HORSHAM DISTRICT COUNCIL CONSULTATION

TO:	Horsham District Council – Planning Dept
LOCATION:	Phases 2 and 3 Land at Wellcross Farm Broadbridge Heath
DESCRIPTION:	Application for Approval of Details Reserved by Condition 2 (Construction Management Plan), ³ (borehole to meet Private Water Supplies), ⁴ (Private Water Supply Management Plan), ⁵ (finished floor levels and external ground levels) and 7 (underground services) to approved application DC/24/0205 Reserved matters application pursuant to condition 5 of outline planning permission DC/19/1897 for the provision of phases 2 and 3 of Land at Wellcross Farm to provide a continuing care retirement community with 94 units of accommodation (C2), with access, infrastructure, open space, landscaping and associated works including an onsite borehole water supply).
REFERENCE:	DISC/26/0013
RECOMMENDATION:	Modification
SUMMARY OF COMMENTS & RECOMMENDATION: We do not wish to offer comments on conditions 2, 3 and 4. Please note Drawings 1163-ESD-XX-00-DR-XX-P1-1001 _ REV P01 refer to utilities for phase 1. Comments for this plan have been provided under DISC/26/0012 which seeks to discharge condition 6 for phase 1 to approved DC/22/1503. <u>

- Drawing 1163-ESD-XX-00-DR-XX-P2-1001 _ REV P01 (Phase 2)

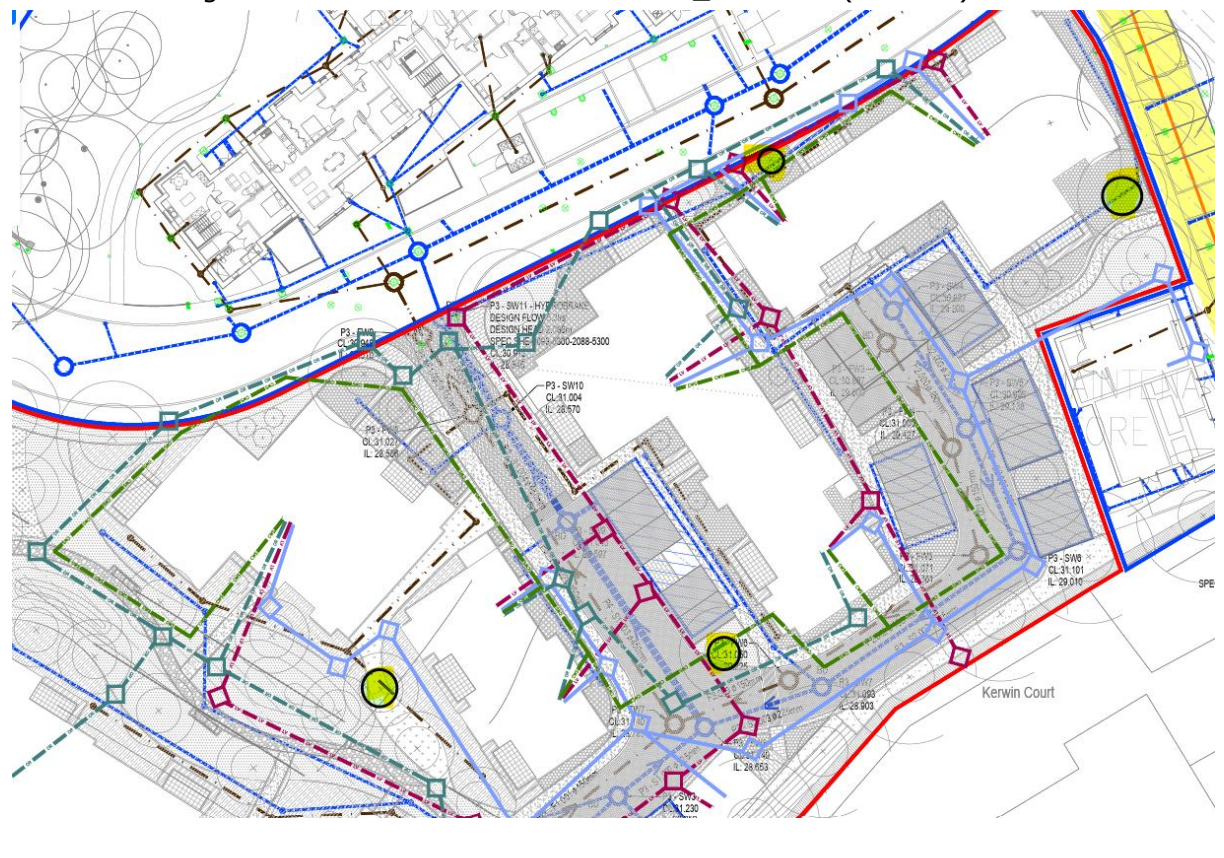
A number of clashes have been identified where we consider that it is unlikely that the proposed trees and landscape strategy can be delivered unless adjustments to the proposed services or trees are made or consideration is given to the use of soil cells systems. Please see mark-up plans below:

In addition, there are concerns with the level of encroachment of the ground levelling works and underground services on the existing T31, also marked on the plan. Please seek further advice from HDC tree officer.
